NUMBER: SB 550-53-001, Rev B  
MODEL: ECLIPSE EA550  
SUBJECT: External Stowage Compartment Door Inspection and Modification

This Service Bulletin provides the steps to enhance the security of the External Stowage Compartment door.

This Service Bulletin provides the steps to inspect the External Stowage Compartment and recommended modification options.

Revision B of this Modification Bulletin updates Effectivity.

Figure 8, Sheet 1. Option 2 - Render Door Inoperative

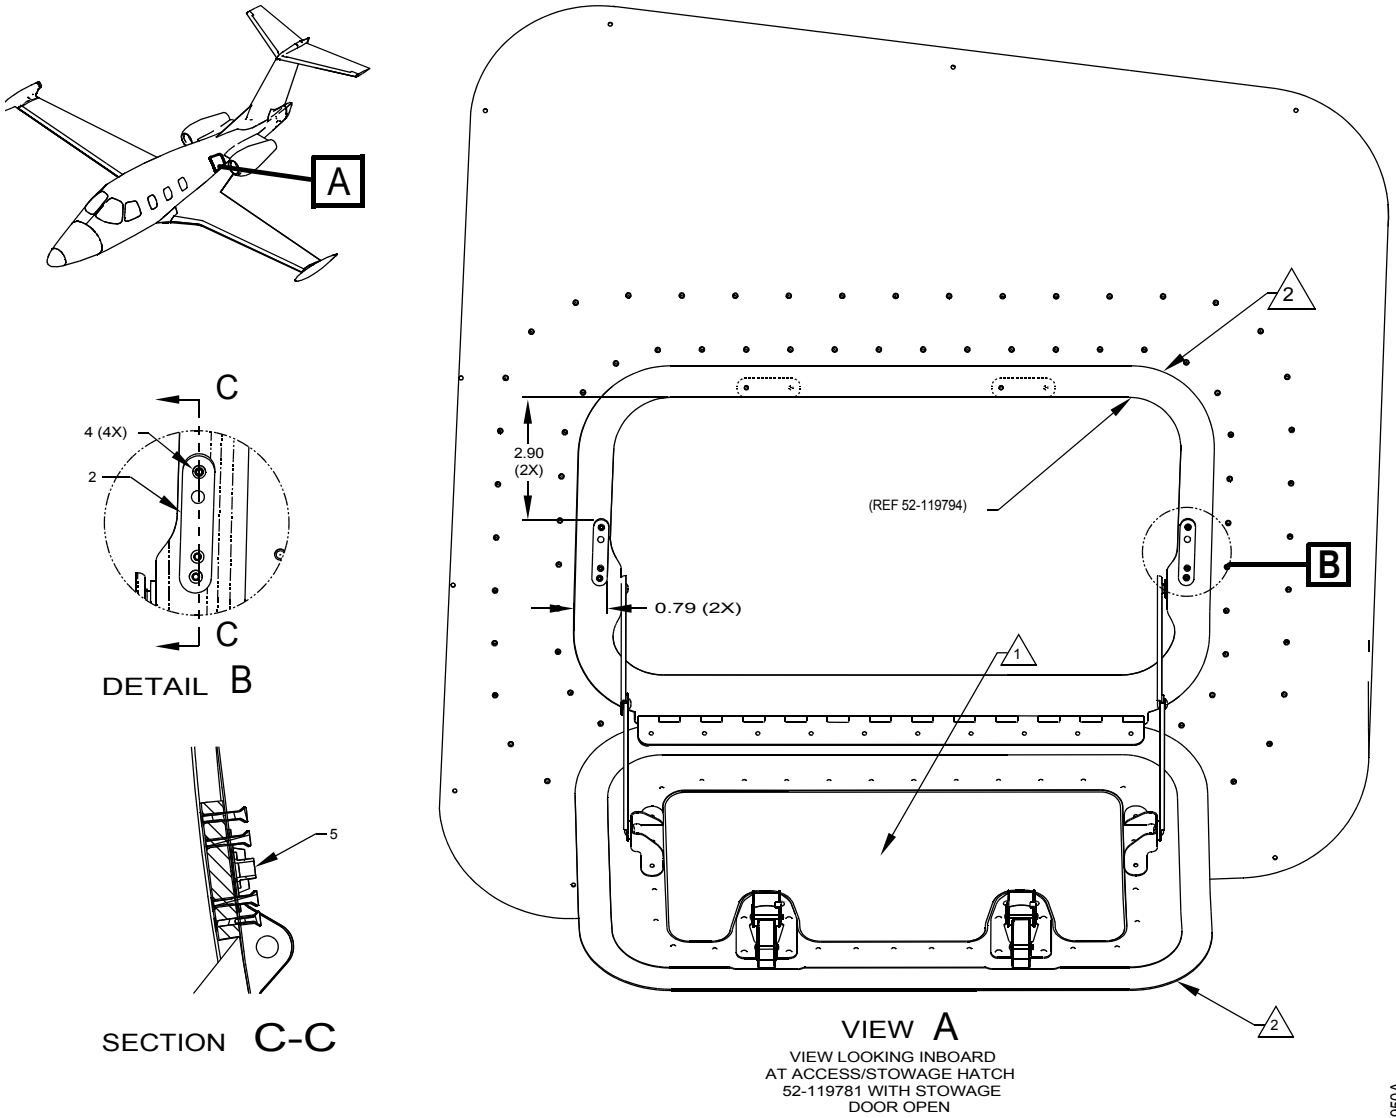
- (1) Locate spacer, P/N 53-125118-2001, (2, [Figure 8, Sheet 1](#)) on to frame and using spacer (2, [Figure 8, Sheet 1](#)) as a template, drill four holes to accommodate rivets, P/N CCR244CS-3-07PR, (4, [Figure 8, Sheet 1](#)). Refer to AMM 20-07-00.

- (2) Treat bare surfaces with Alodine (Chemical Conversion Coating). Refer to AMM 20-09-00 - Aircraft Finishes.
- (3) Fasten spacer, P/N 53-125118-2001 (2, [Figure 8, Sheet 1](#)) and nut plate P/N NAS1791A08-1, (5, [Figure 8, Sheet 1](#)) to frame using four rivets, P/N CCR244CS-3-07PR, (4, [Figure 8, Sheet 1](#)). Refer to AMM 20-07-00 - Attaching Hardware.

- (4) Repeat steps 3.C.1, 3.C.2, and 3.C.3 on opposite side.
- (5) Mark with indelible ink "Modified by SB 550-53-001" on inner door. Reference Flag Note 1, [Figure 8, Sheet 1](#) for location.

- (8) Remove (2) screws, P/N AN525-832R10, (3, [Figure 8, Sheet 1](#)) and open door.
- (9) Fill the entire periphery between doubler, P/N 52-119794 and door with sealant PRC-2001 or equivalent. Ensure adequate squeeze out upon door closure. Remove excess sealant and ensure door, when closed is flush with the surrounding aircraft skin within  $-.030/+0.030$  inch. Refer to AMM 20-08-00 - Sealants and Adhesives, and Flag Note 2, [Figure 8, Sheet 1](#).
- (10) Install (2) screws, P/N AN525-832R10, (3, [Figure 8, Sheet 2](#)) to secure door. Refer to AMM 20-07-00 - Attaching Hardware.

NOTE: If interference exists between the radius of the door doubler, P/N 52-119794 and the spacer, P/N 53-125118-2001, it is permissible to trim the spacer, P/N 52-125118-2001 to adjust the thickness of the spacer to meet flushness criteria between the surrounding aircraft skin and the door of  $-.030/+0.030$  inch.

Figure 8, Sheet 2. Option 2 - Render Door Inoperative

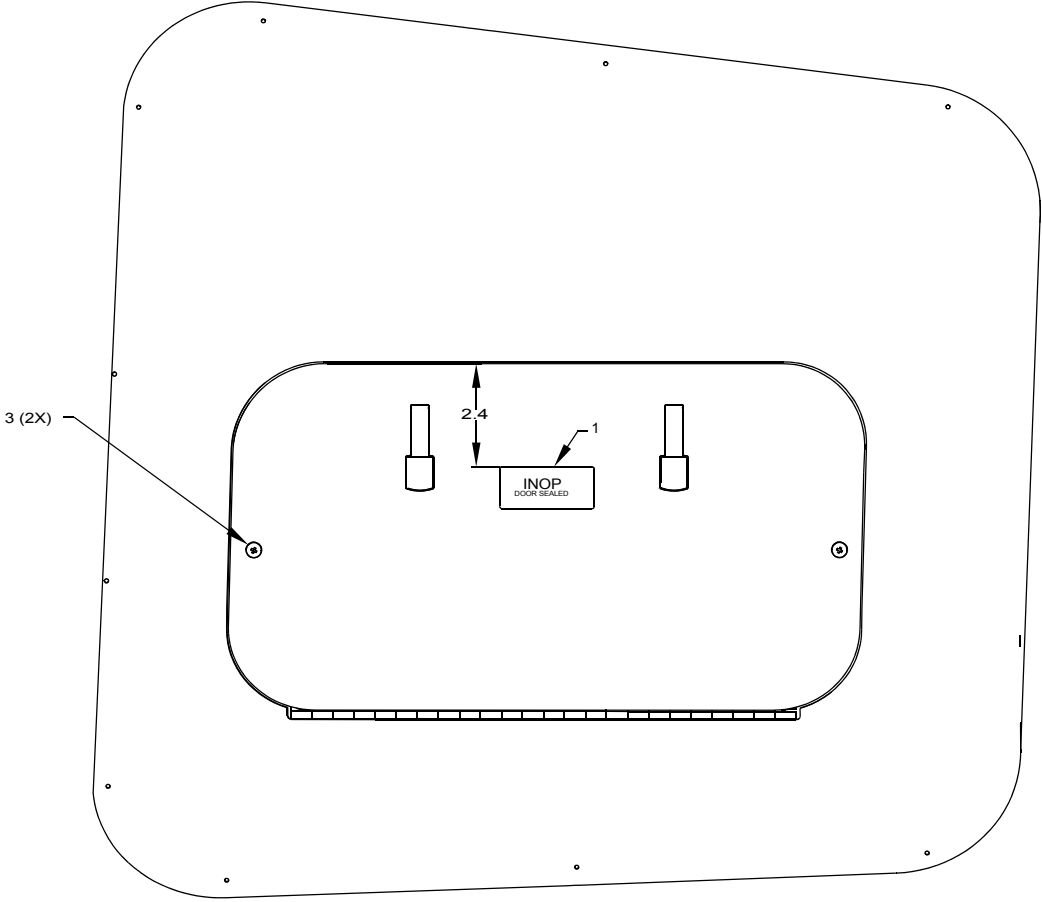
- (6) Close door and apply Placard, Door Inop, P/N 11-125116-2001, (1, [Figure 8, Sheet 2](#)) in location shown. Refer to View D.
- (7) Secure door with two screws, P/N AN525-832R10, (3, [Figure 8, Sheet 2](#)). Check for flushness between the door and surrounding aircraft skin is within  $-.030/+0.030$  inch.

**Figure 9. Overlap Assessment**

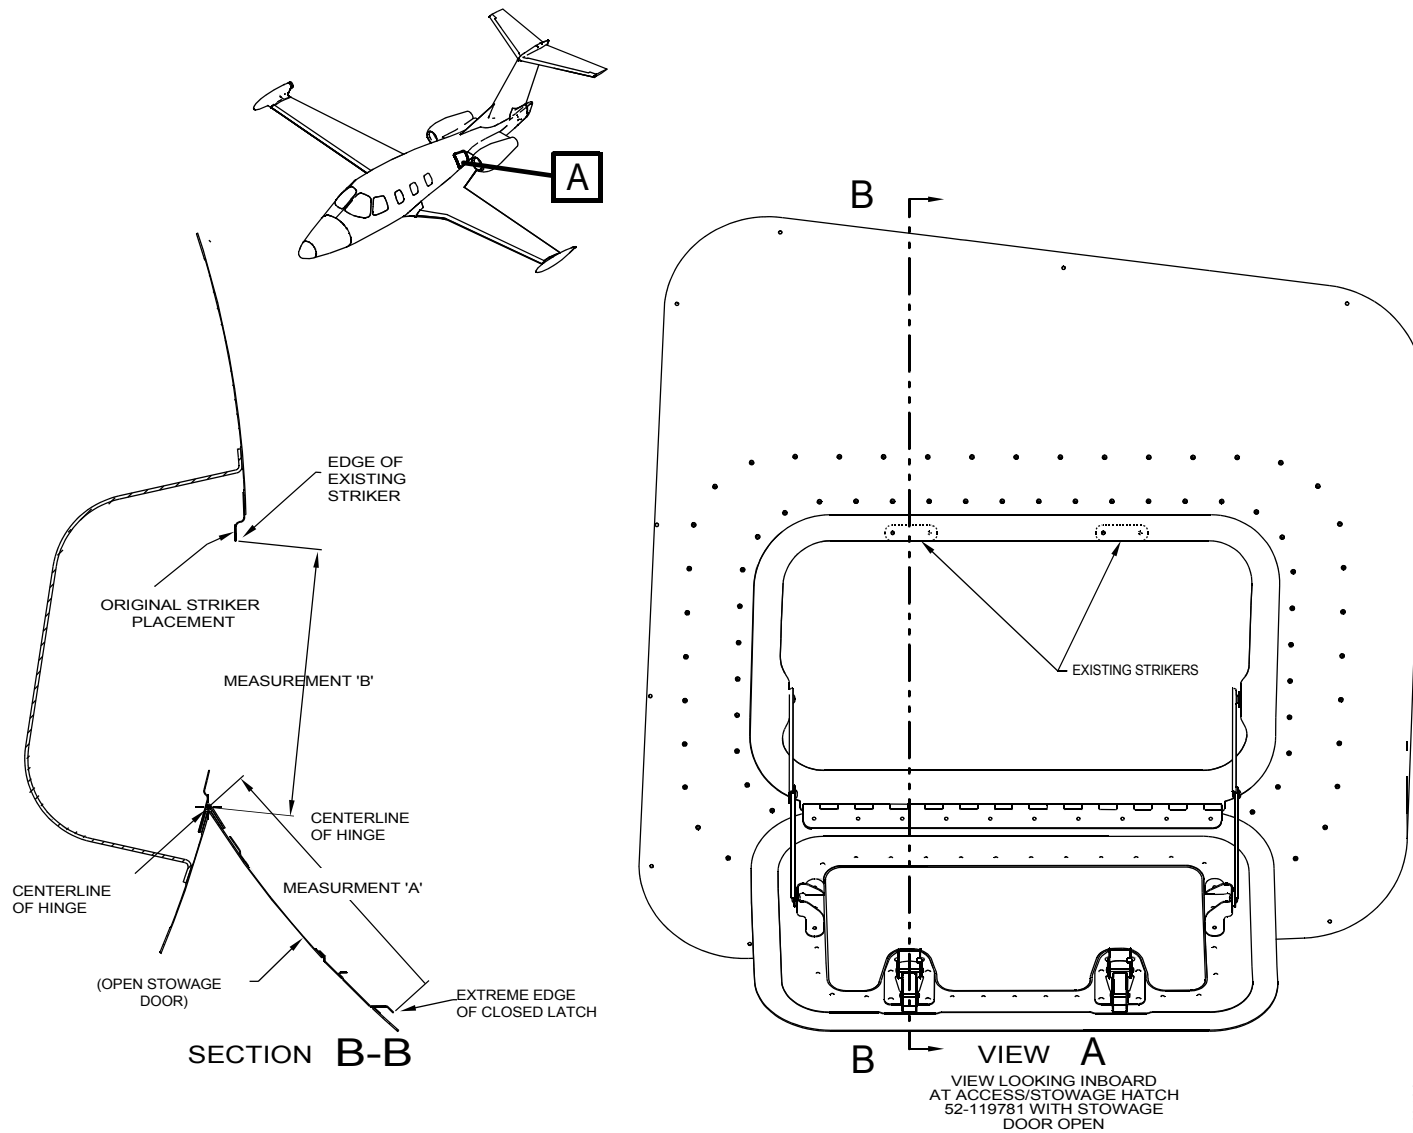
- (1) Place both latches in closed position.
- (2) For the forwards hinge and from the hinge centerline. Obtain two measurements: Refer to [Figure 9](#)
  - (a) Measurement A: Between the hinge centerline and extreme edge of closed latch.
  - (b) Measurement B: Between the hinge centerline and the nearest edge of the door opening or the striker plate.
  - (c) Engagement (C) is defined as (A) minus (B).
  - (d) Record (A), (B), and (C) measurements.
- (3) Repeat Step 3.A.(4) for the aft hinge.
- (4) If engagement is equal to or greater than 0.34 inch on either hinge, striker replacement can not be done.
- (5) If engagement is (C) is less than 0.34 inch on both hinges, proceed to replace original strikers with new striker.

Measurement C must be less than 0.34 inch

Figure 10. Option 3 - Replace Strikers

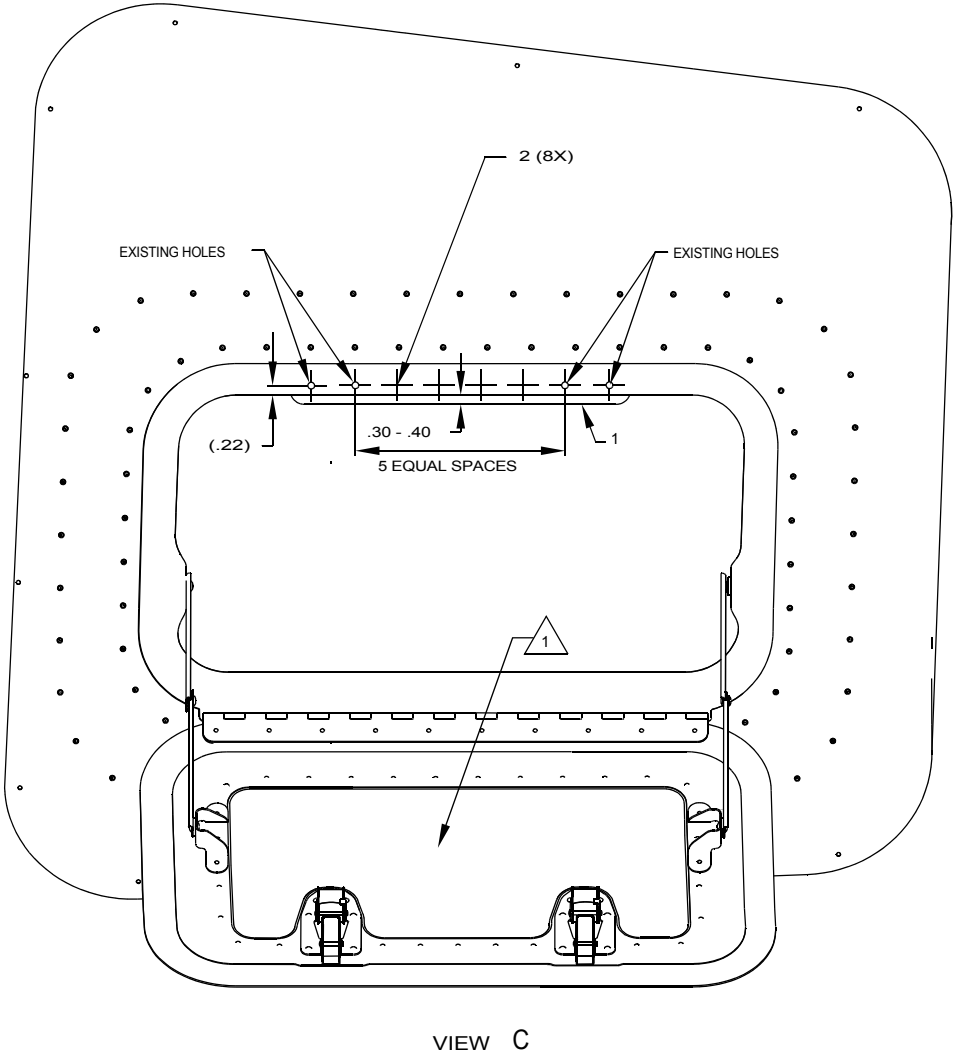
- (6) Remove and scrap the following:
    - (a) Rivets, P/N NAS1097AD3-3, Qty 4.
    - (b) Plate, Strike, External Stowage Compartment, P/N 52-119796-2001, Qty 2.

- (7) Mark "Modified by SB 550-53-001" with indelible ink in location shown by Flag Note 1, [Figure 10](#).
  - (8) Locate new striker P/N 53-125117-2001 (1, [Figure 10](#)) so that engagement (C) after installation will be 0.30 - 0.40 inches using existing (4) holes from removal of original striker plates and drill (4) holes to accept rivets P/N NAS1097AD3-3. (2, [Figure 10](#)).

- (9) Fasten new striker P/N 53-125117-2001 (1, [Figure 10](#)) to frame with (8) rivets, P/N NAS1097AD3-3. (2, [Figure 10](#)).
  - (10) If necessary, replace the form-in-place seal around door opening.

NOTE: The form-in-place seal must to allow the door, when closed, and the 311-AL Maintenance Bay Panel skin to be flush with in -.030/+ .030 inch to prevent abnormal airflow.
    - (g) Close door and allow sealant to cure.
    - (h) After sealant has cured, open door.
    - (i) Inspect the form-in-place seal for cracking, tears and flushness.
- CAUTION: Use care when cutting the sealant as not to scratch the metal.
- (j) Trim off excess sealant along the edges of the painters tape on the door.
  - (k) Remove Painters tape from all surfaces.
  - (l) Touch-up any scratched or bare aluminum with Alodine, primer and topcoat if necessary. Refer to AMM 20-09-00 - Aircraft Finishes.
- (11) Close and latch External Stowage Compartment door.
